PENTAGON RESERVATION MASTER PLAN

Arlington County, VA

STAFF RECOMMENDATION

May 26, 2005

- **Improvement to vehicular and pedestrian circulation**

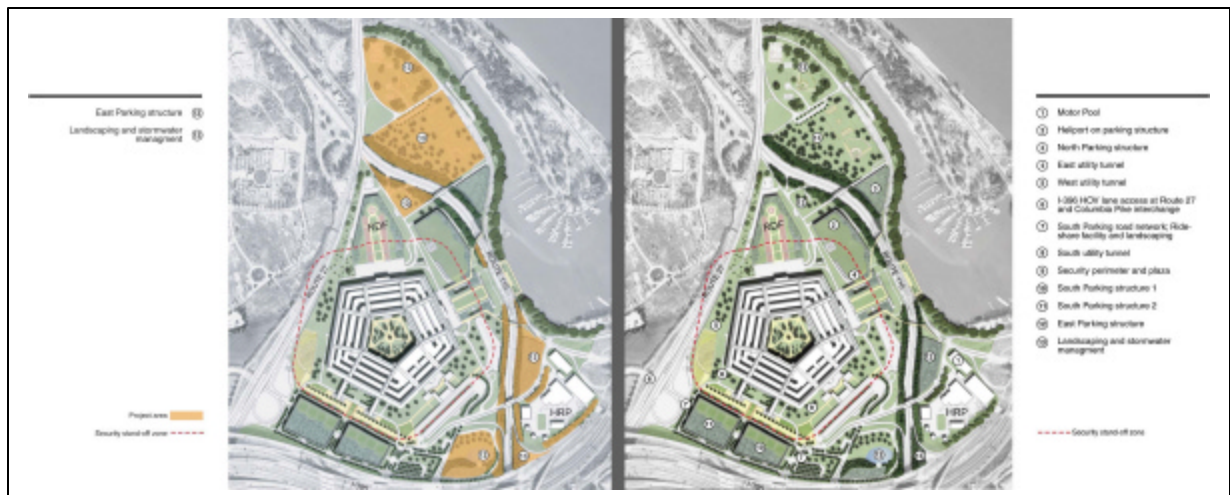
While the Master Plan addresses most of the vehicular concerns within the Pentagon Reservation and mostly pertains to clearing vehicle traffic off of the reservation, VDOT has expressed several concerns with traffic entering the reservation and potentially backing up on the surrounding road network while waiting to enter parking areas on the reservation. Specifically, the location of the proposed HOV ramp may limit the length of the ramp. VDOT recommends a detailed traffic analysis to configure the ramp and design adequate traffic control. VDOT also recommends considering strategies to assure that inbound traffic is not blocked from the northbound 1-395 HOV ramp at Eads Street and South Rotary Road during the morning peak demand. Staff supports the proposals to upgrade existing pedestrian circulation at grade and in an existing tunnel to Army-Navy Drive. Improving Rotary Road vehicle circulation, clearly defining roadways through the South Parking area and designating lanes for pick-up, drop-off, and informal rideshare will contribute to pedestrian safety. Tunnels proposed below North Rotary Road would minimize pedestrian vehicle conflicts by separating pedestrian from vehicle circulation at points of high conflict.
